Clinton Power Station

Subject: Clinton Power Station Proposed Amendment of
Facility Operating License No. NPF-62 (LA-98-007)

**Revise CPS Technical Specifications Surveillance Requirement (SR) SR 3.6.4.1.4 for
Secondary Containment Drawdown Testing**

Marked-Up Pages of the Technical Specifications

Figure 3.6.4.1.1 (page 1 of 1)
Secondary Containment Drawdown Time
for 1500 cfm Boundary Leakage

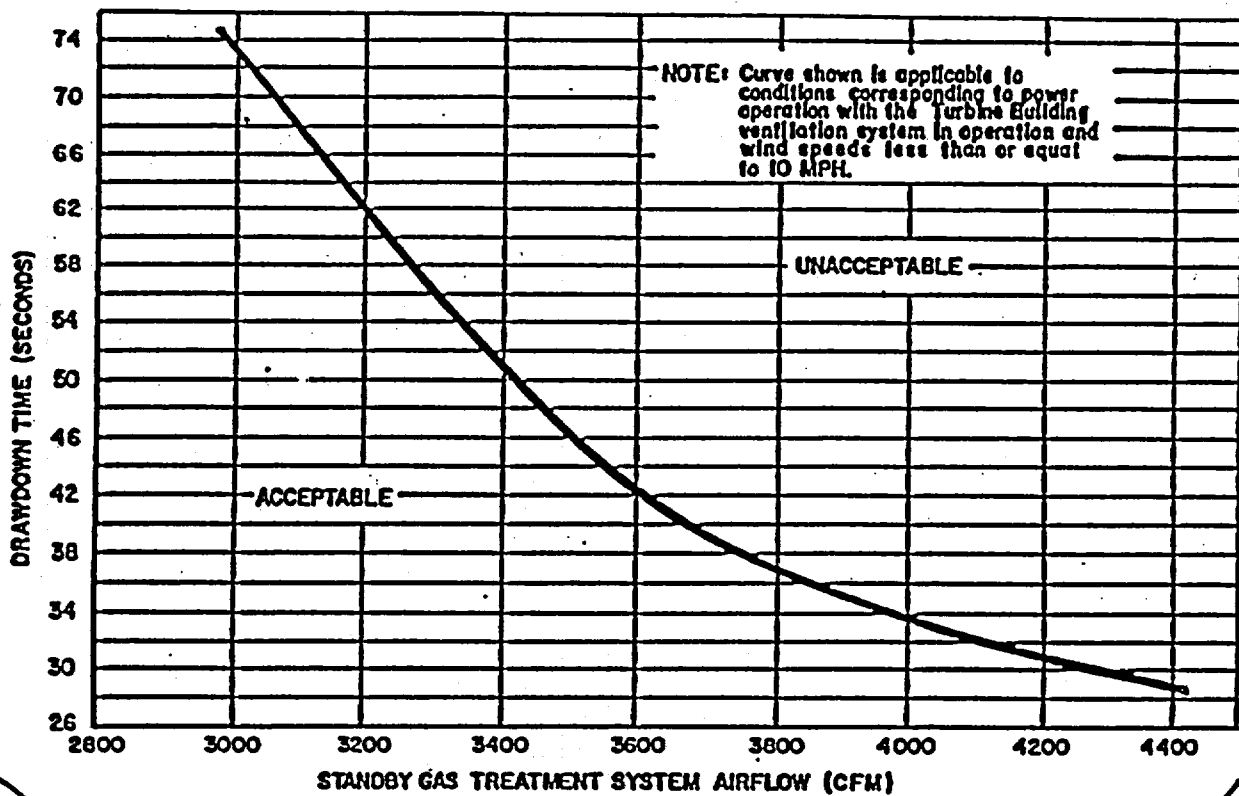
3.6.4.1.4. No figure in the SR is needed to maintain this link, as the current figure (Figure 3.6.4.1-1) does not explicitly refer to the 188-second basis requirement either.

The proposed Technical Specification (TS) change eliminates an inconsistency between the Secondary Containment surveillance requirement (SR 3.6.4.1.4) and the associated Bases. The proposed change (1) revises the wording of SR 3.6.4.1.4 to verify the time to draw down the secondary containment to ≥ 0.25 inch water gauge for each standby gas treatment (SGT) subsystem is within the required time; and (2) relocates the specific acceptance criteria (existing TS Figure 3.6.4.1-1) to plant procedures and the TS Bases.

Delete this figure

Verify each standby gas treatment (SGT) subsystem will drawdown the secondary containment to ≥ 0.25 inch of vacuum water gauge within the required time.
